# Access Compliance Report

## Public Rights-of-Way

Intersection ID: 14468	Main Street: E_TREMONT_AV	Cross Street: EUCLID_AV	Location: W
ADA ID: DBFDBDAAD165	Ramp Type: PerpDiag	Initial Pass/Fail: Fail	Overall Compliance: No
Severity Score: 37.5			
Codes/Mitigation Info/Possible Solution		Field Measurements/Component Compliance

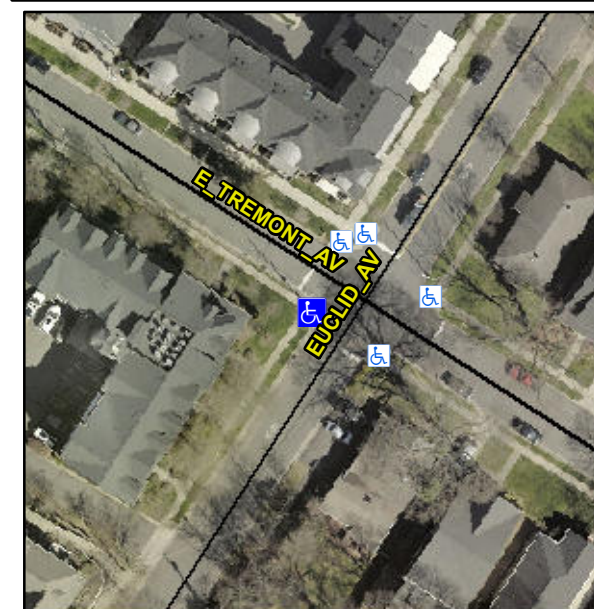
**Not Found, R304.2.2, R304.5.3**

Compliance	Description	Data	Compliance	Description	Data
N/A	Ramp Length (in)	104.0	No	Ramp Slope (%)	17.1
Yes	Ramp Width (in)	48.0	No	Ramp XSlope (%)	5.3
N/A	Flare Type LT	N/A	N/A	Flare Type RT	N/A
N/A	Flare Slope LT (%)	N/A	N/A	Flare Slope RT (%)	N/A
N/A	Flare Traversable LT?	N/A	N/A	Flare Traversable RT?	N/A
N/A	Landing Length (in)	N/A	N/A	DWS Provided?	N/A
N/A	Landing Width (in)	N/A	N/A	DWS Contrast?	N/A
N/A	Landing Slope (%)	N/A	N/A	DWS Length (in)	N/A
N/A	Landing X Slope (%)	N/A	N/A	DWS Full Width?	N/A
N/A	Landing Curb? (Y/N)	N/A	N/A	DWS Offset (in)	N/A
N/A	Shared Landing?	N/A			
N/A	Gutter Ponding?	N/A	N/A	Gutter Slope (%)	N/A
N/A	Gutter Lip Ht (in)	1.0	N/A	Gutter X Slope (%)	N/A
N/A	Painted X Walk1?	No	N/A	Painted X Walk2?	No
	X Walk 1 Direction	To SE		X Walk 2 Direction	To NE
N/A	X Walk 1 Width (in)	N/A	N/A	X Walk 2 Width (in)	N/A
	X Walk 1 Slope (%)	1.4		X Walk 2 Slope (%)	1.0
	X Walk 1 X Slope (%)	1.9		X Walk 2 X Slope (%)	2.4

**Remove & Replace Curb Ramp With Two New Directional Ramps or Equivalent.**
